Docket # 6 & 7 BAR #2022-00455& 2022-00464 Old and Historic Alexandria District November 2, 2022

**ISSUE:** Permit to Demolish/Capsulate (partial) and Certificate of Appropriateness

508 North Washington Street

Staff recommends approval of the Permit to Demolish/Capsulate (partial) and Certificate of Appropriateness for an addition and alterations with the following conditions:

SDASK-10

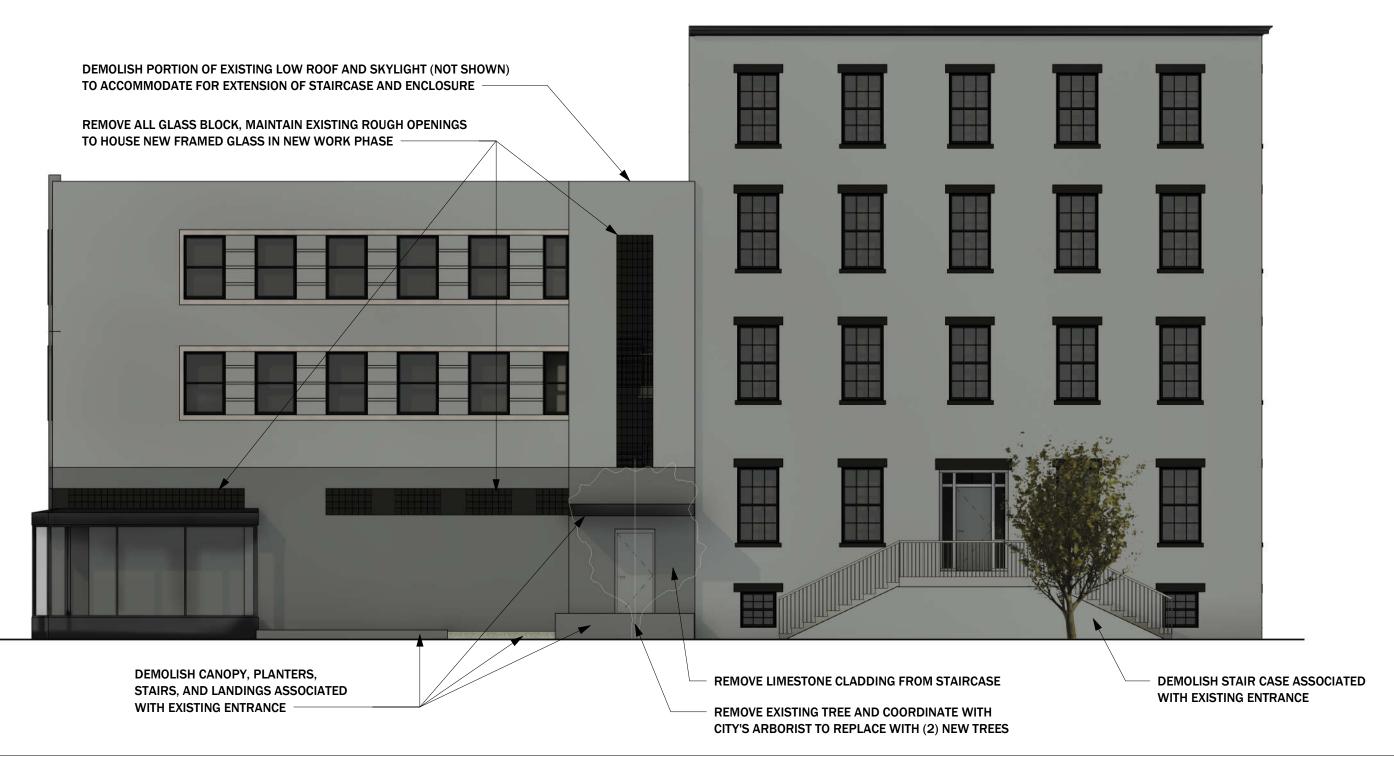
The proposal includes a new exterior stair configured similar to the existing stair with a landing at the top accessed by stairs from both the north and south sides with the southern stairs in front of the stair tower on the southern portion of the building. Staff supports the relocation of the stair and finds the asymmetrical composition compatible with the overall east elevation. However, staff recommends that the design for the stair be modified to eliminate the stairs on the south side of the landing, leaving access only from the north side (Figure 5). An important hallmark of the existing building is that there is a clear differentiation between the northern and southern sections. Extending the new exterior stair in front of the stair tower blurs this differentiation and does not allow the stair tower to read as a distinct form. The recommended reconfiguration of the exterior stair would reinforce the basic organization of the east elevation and the differentiation between the two building portions.

According to the minutes from the 1986 BAR hearing where this entry was discussed, one of the conditions of approval was that the applicant introduce a recessed panel into the face of the masonry on the base of the stair to "reduce the visual mass of the masonry." The current stair includes a small, recessed arch centered on the stair in response to this comment. Staff recommends that the applicant include a similar detail in the new exterior stair.

- 1. The proposed exterior stair be revised with stairs only on the north side and a vertical masonry plane aligned with the north edge of the stair tower on the south side. The face of the new exterior stair will include an inset section similar to existing stair.
- 2. The proposed fourth floor stair enclosure be differentiated from the existing structure and the proposed cornice be replaced with a parapet similar to the adjacent on the southern portion of the building.
- **3.** Glazing in existing and proposed vertical slot of stair enclosure be fritted glass to be similar to glazing above storefront.
